**RE: Champion Xpress Car Wash  
7509 Menaul Blvd. NE  
Revised Grading and Drainage Plan  
Engineer's Stamp Date: 03/11/21  
Hydrology File: H19D091**

Based upon the information provided in your submittal received 03/11/2021, the Revised Grading and Drainage Plan is approved for Building Permit and SO-19 Permit.

C-3.0

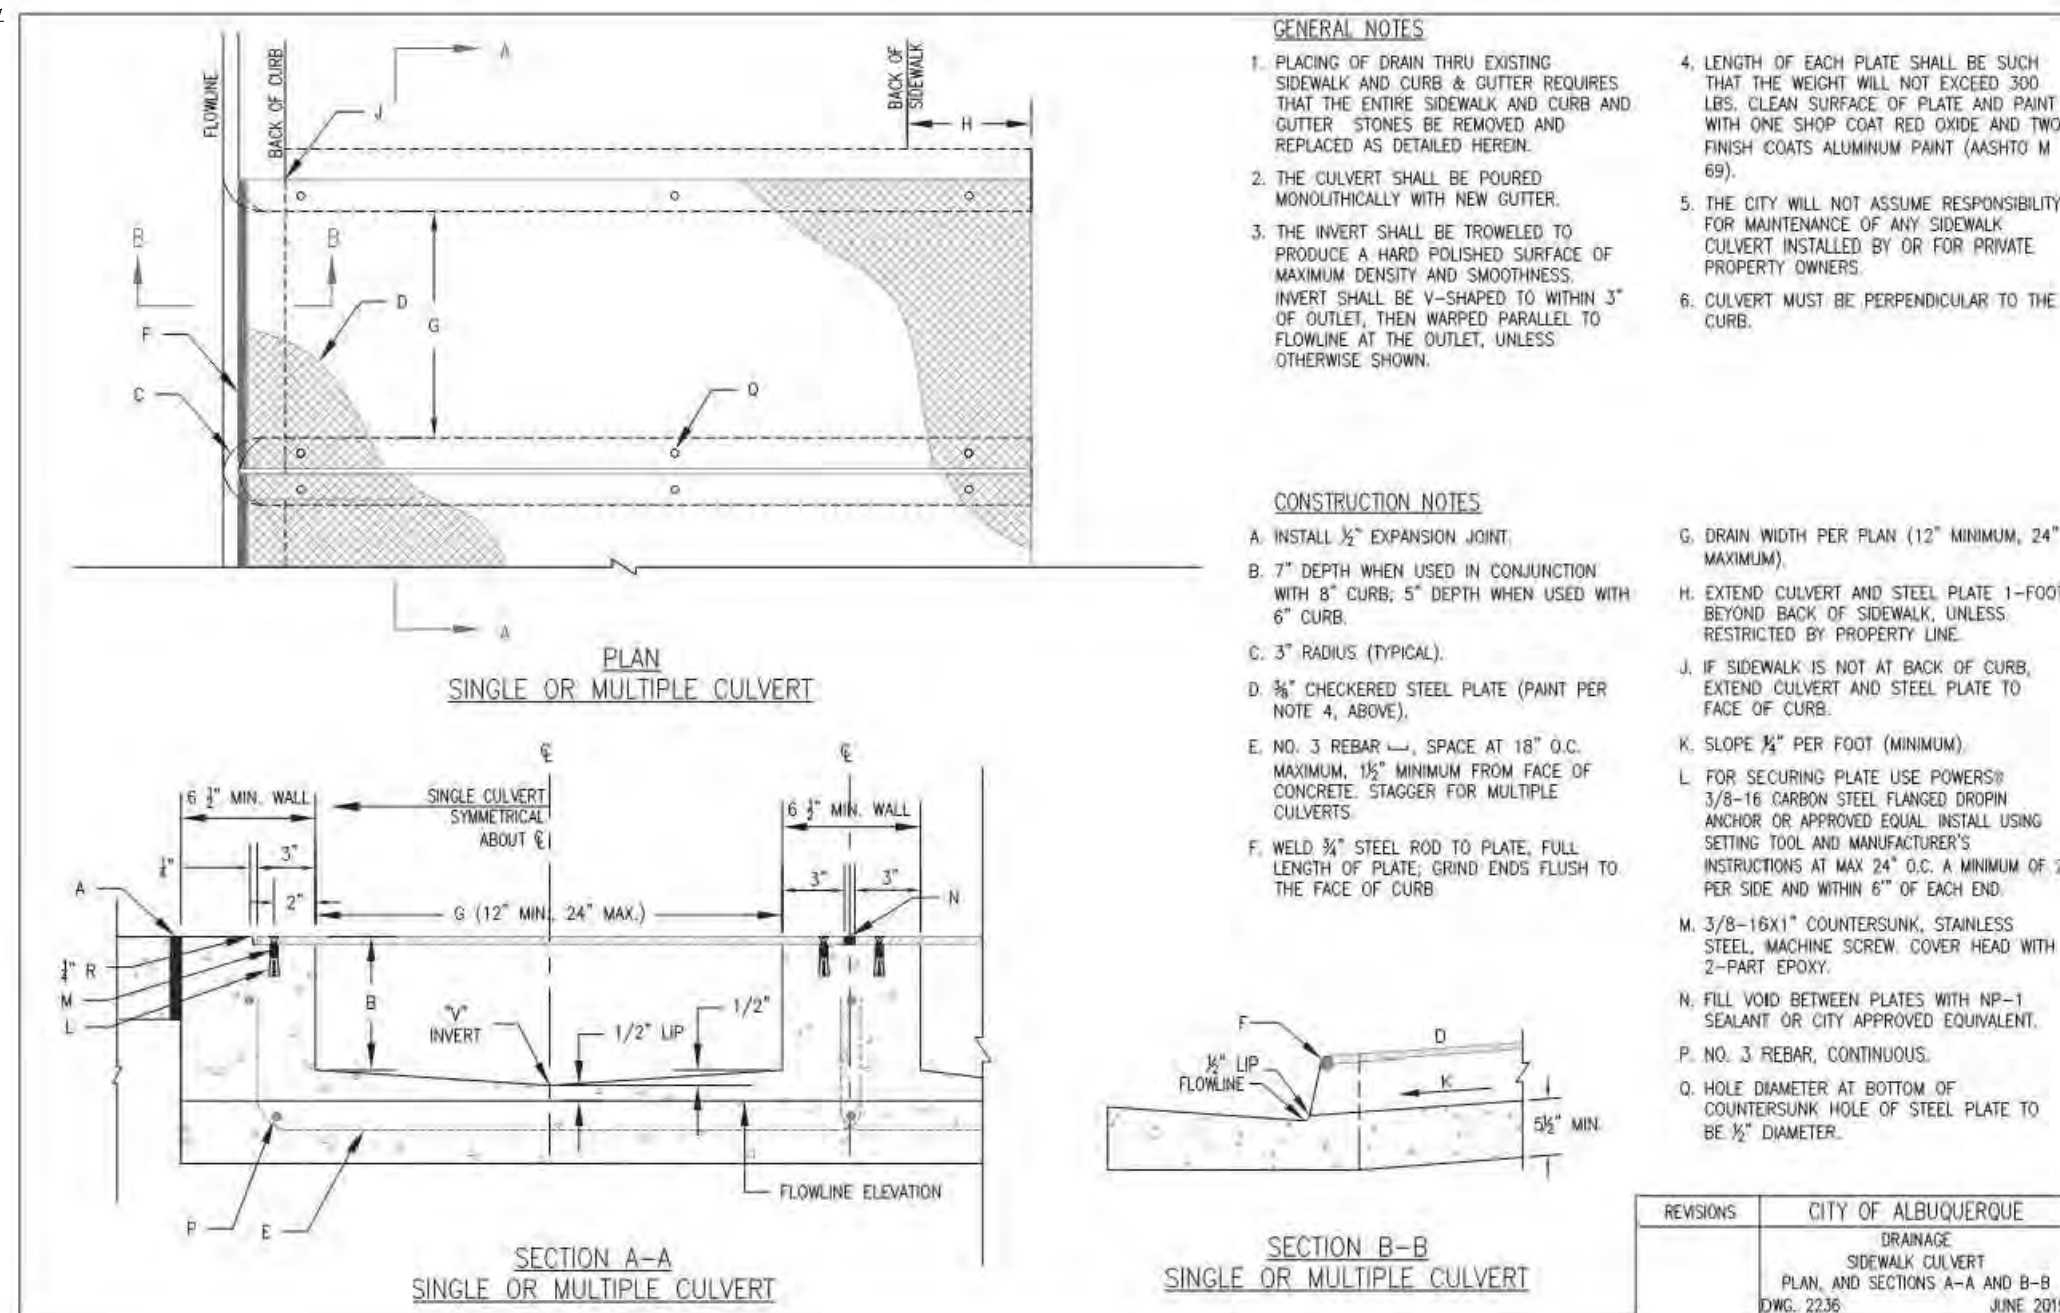
Also, please provide the Drainage Covenant for the proposed stormwater quality pond per Article 6-15(C) of the DPM prior to Permanent Release of Occupancy. There is a recording fee (\$25, payable to Bernalillo County). Please contact Charlotte LaBadie ([clabadie@cabq.gov](mailto:clabadie@cabq.gov), 924-3996). Due to COVID-19, please follow the instructions:
